Post Accident AP1000 Containment Leakage

An Unreviewed Safety Issue

Fairewinds Associates, Inc, April 7, 2010

A Report by Arnold Gundersen, March 26, 2010
Chief Engineer, Fairewinds Associates, Inc

Figure 1

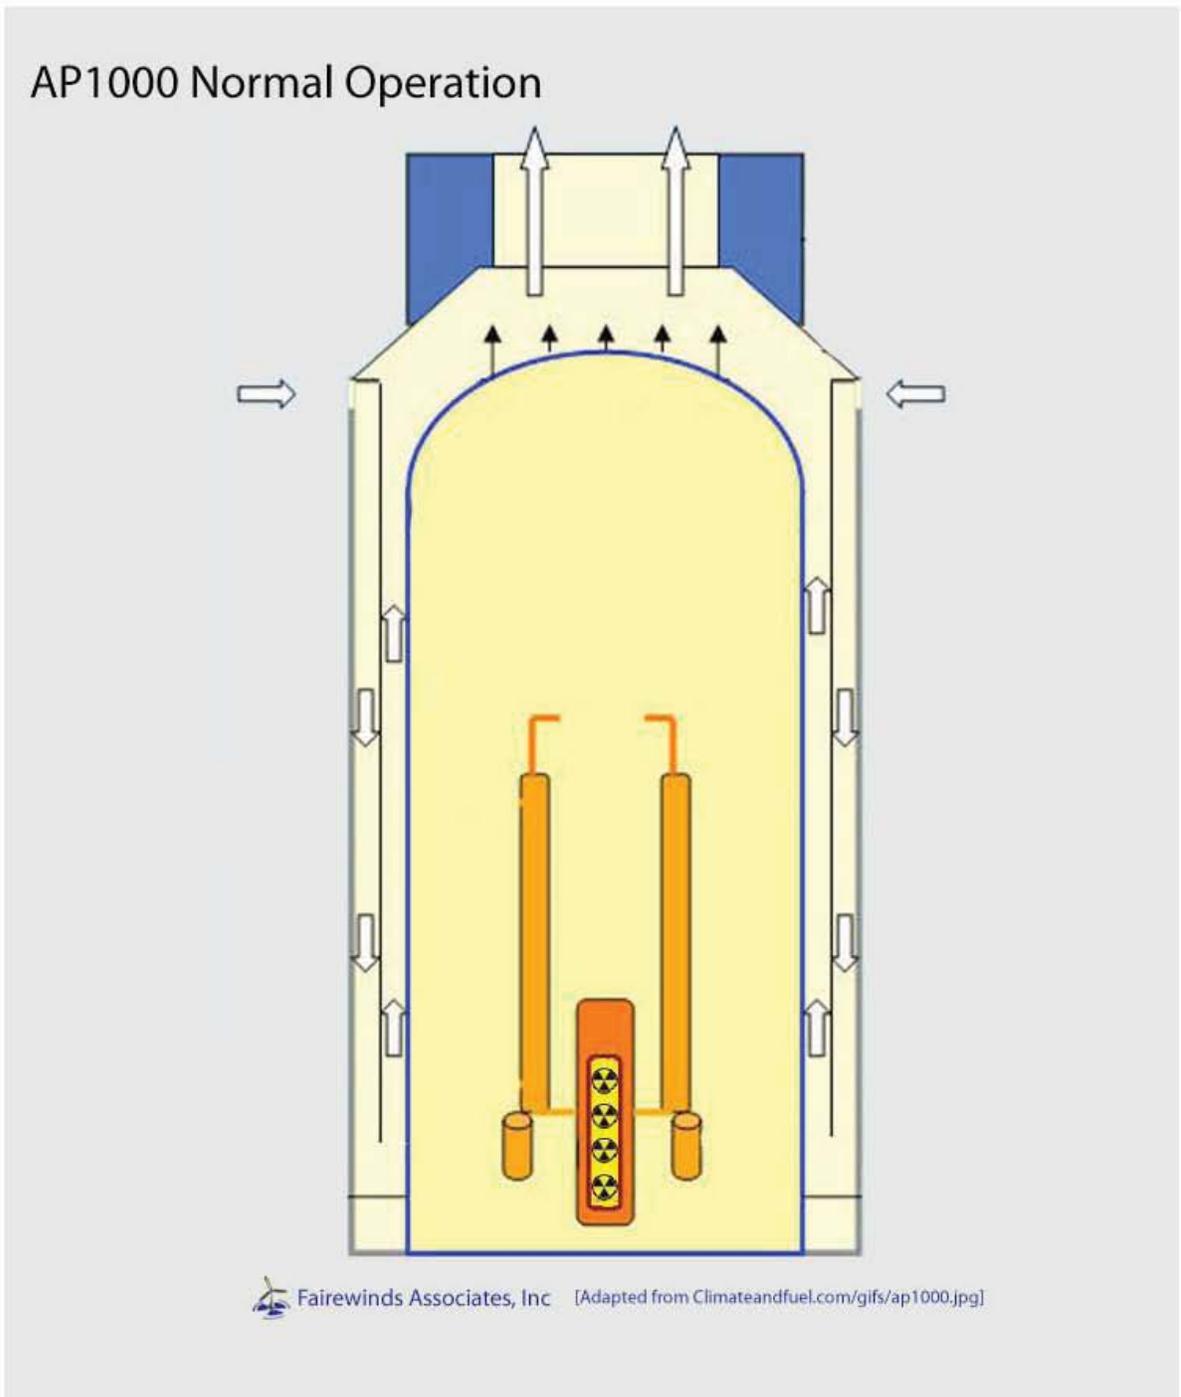
- Figure 1 – AP1000 in normal operation.
- Figure 2 – AP1000 design basis accident begins.
- Figure 3 – AP1000 containment hole opens as containment fills with radioactive gases.
- Figure 4 – AP1000 chimney effect draws radioactivity directly into the environment.
